Title: B100\_2BSST\_875 CHANNEL A  
Rev: R5

File: Channel A R5.sch  
Date: 17/02/2005

REV 4 CHANGES		Title: B100 2BSST 875 CHANNEL B	
		Rev: R5	
File: Channel B R5.sch		Sheet: 1 of 1	
Date: 17/02/2005		Drawn: ST

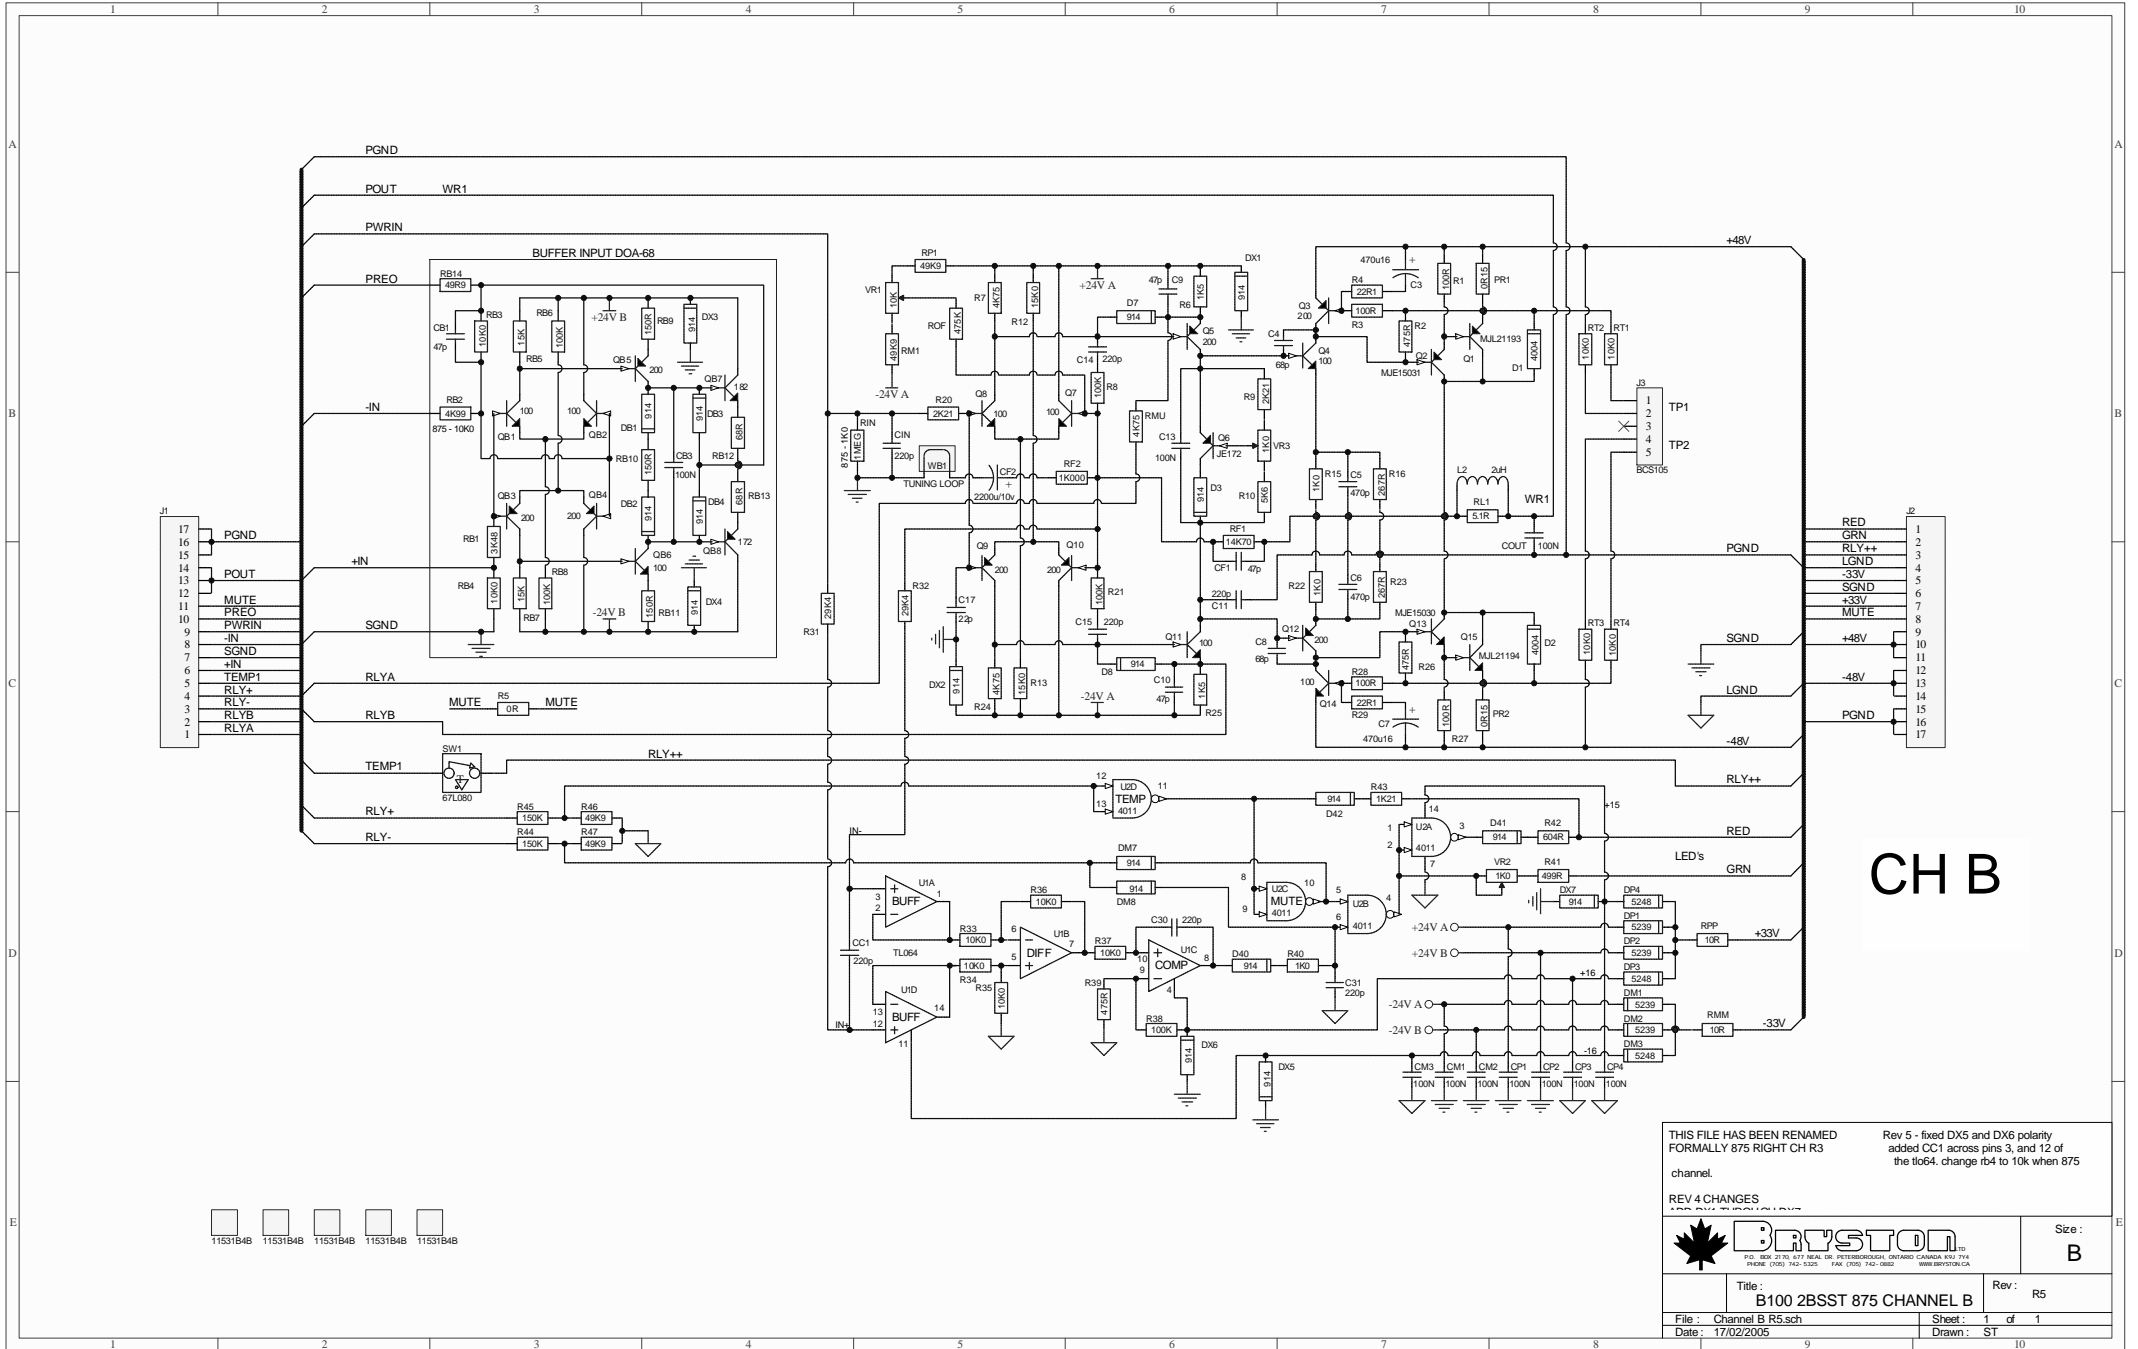
THIS FILE IS RENAMED  
FORMERLY 075 LEFT CH R3  
REV 4 CHANGES  
ADD DX1 THROUGH DX7  
OPTIONS FOR R1V, RB2 AND RB4

REV 5 - ADD CC1 ACROSS TLO64 INPUTS  
CHANGE POLARITY OF DX5 AND DX6  
R44 RTAYR 10K FOR ALL APPLICATIONS
